AFFIDAVIT

I, Charles C. Stokes, am providing this statement of my own volition in response to various Pacific Gas and Electric (PG&E) submittals to the NRC. This is intended to follow up on issues which I have raised in prior statements to the Commission and which I feel must still be addressed in detail by PG&E Diablo Project management before Unit 1 is allowed to go beyond 5% power. In some cases my comments suggest necessary methodological steps to obtain adequate correction action on my allegations, largely confirmed by Mr. Yin. In other cases, my comments expose false or misleading statements by PG&E in their response to Mr. Yin's inspection report.

In response to PG&E letters on the subject of **Tube Steel Radius** and **Flare-Bevel Welds** as addressed in the April 7, 1984 and April 11, 1984 to the members of the Appeal Board, and PG&E letter No.: DCL-84-083, DCL-84-164, DCL-84-166, and DCL-84-190.

ATTACHMENT 1

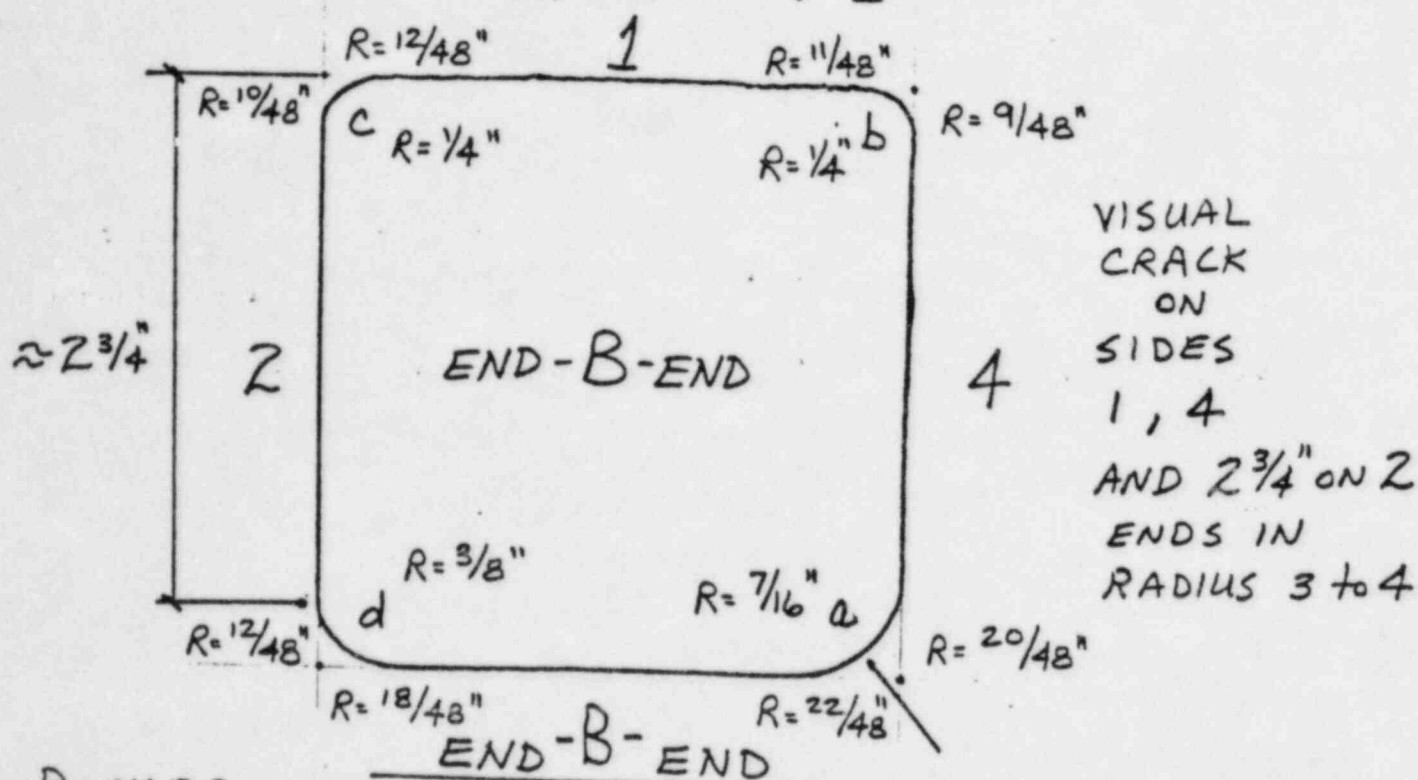
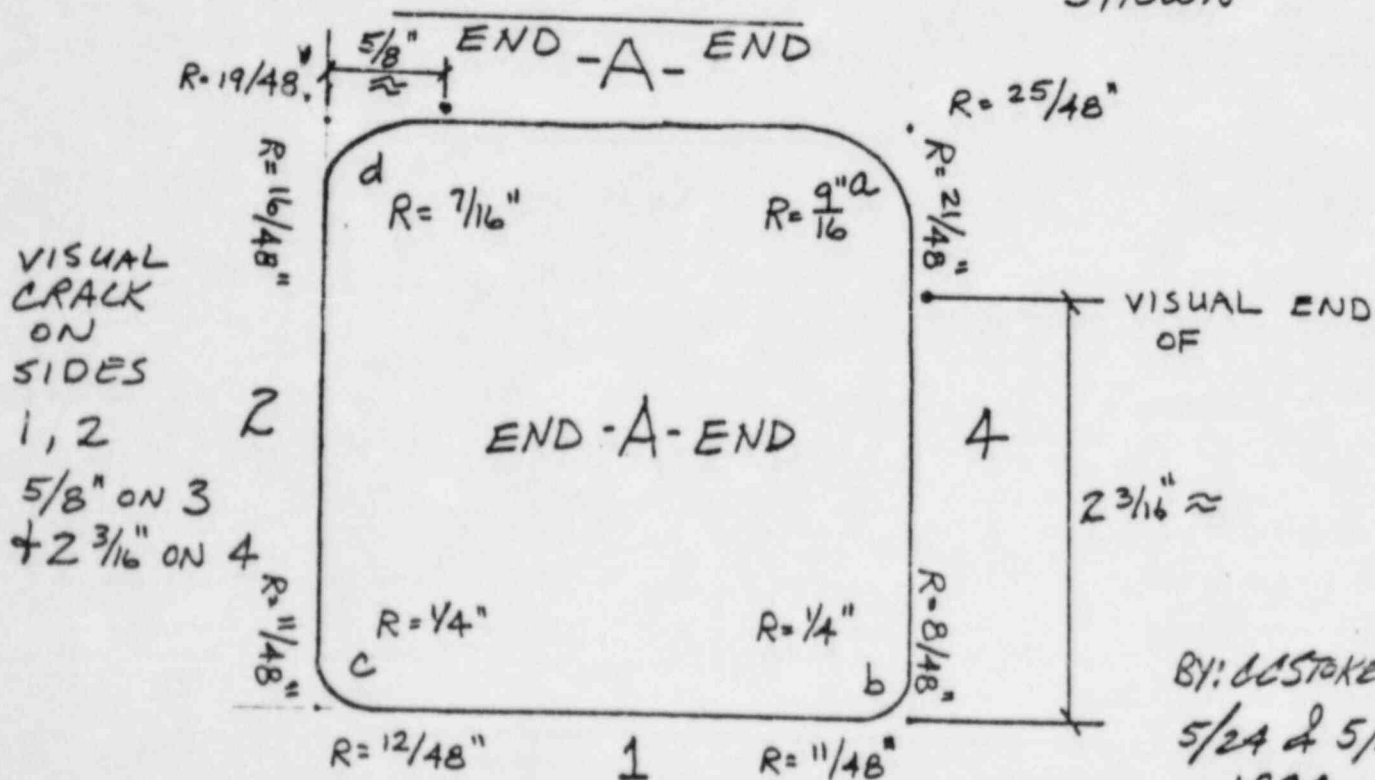
This tubing (Attachment 1 sketches) not only has a corner radius less than 2t but has only one (1) corner which is 2t. Three corners are less than 2t, of which two (2) are only 1t as I and others have confirmed. It measures 1t using the Straight Ruler Method (per PG&E) and using the Concave Radius Gage Method. An additional flaw exists, which before seeing this piece, not even I was aware of. The tube wall has what appears to me to be a lamination crack running all the way around its' perimeter. This lamination crack is almost exactly at the center line of the tube wall.

ATTACHMENT 2.a

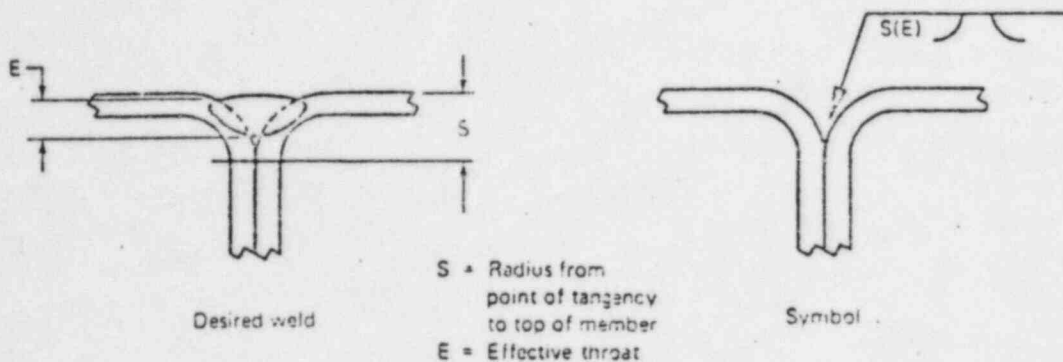
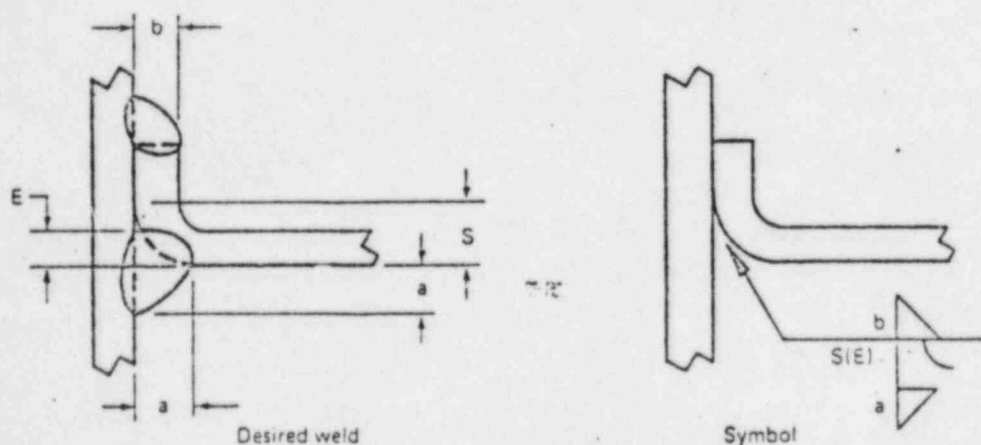
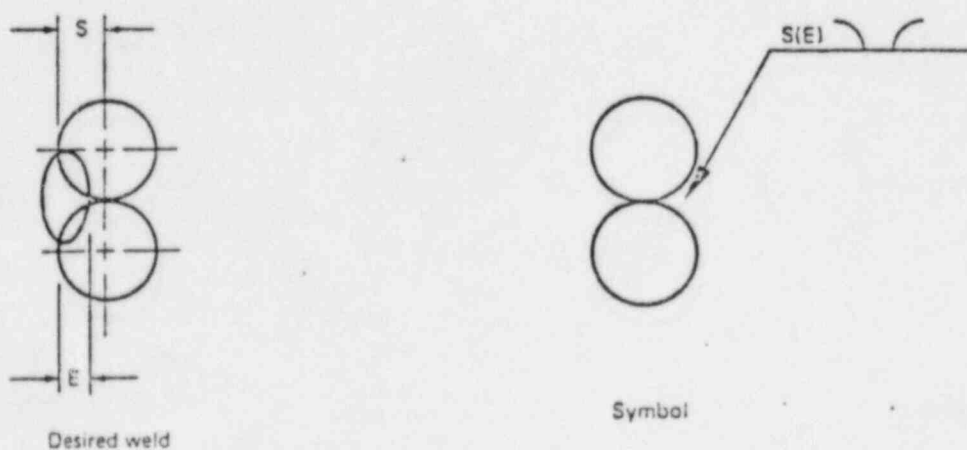
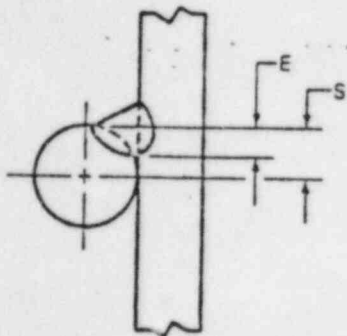
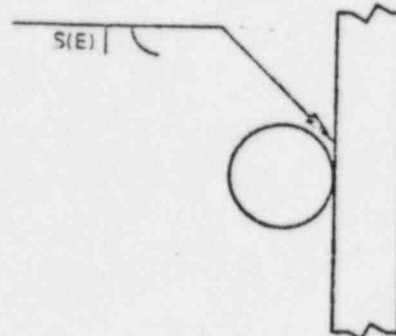
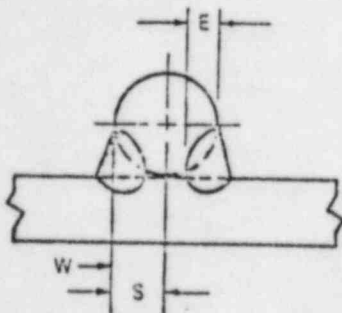
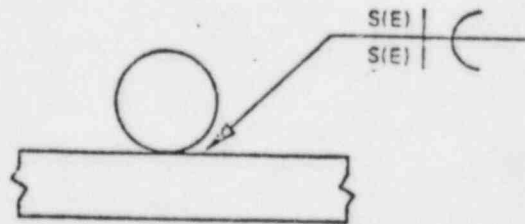
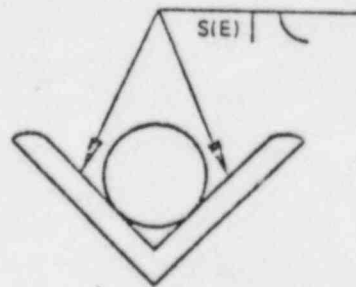
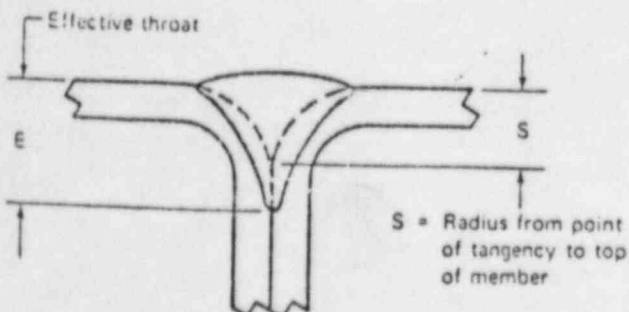
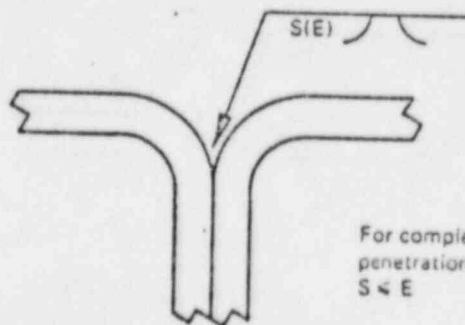
As an engineer and in accordance with the established guidelines of relevant professional CODES, I feel the above data should be factored into the methodology. In the case of pipe support steel design, I will and would like to see applied at Diablo Canyon the definition of tube steel radius as defined by either the (AISC) or the (AWS) CODES. Based on my knowledge, and after review of pages 4-131 to 4-149 and Section 1.17 "WELDS" on page 5-44 of the AISC manual, I decided that the answer must be within the AWS document. Both documents govern the construction of pipe support steel, but on page 4-149 and 5-44 the AISC references the reader to the AWS code for this issue.
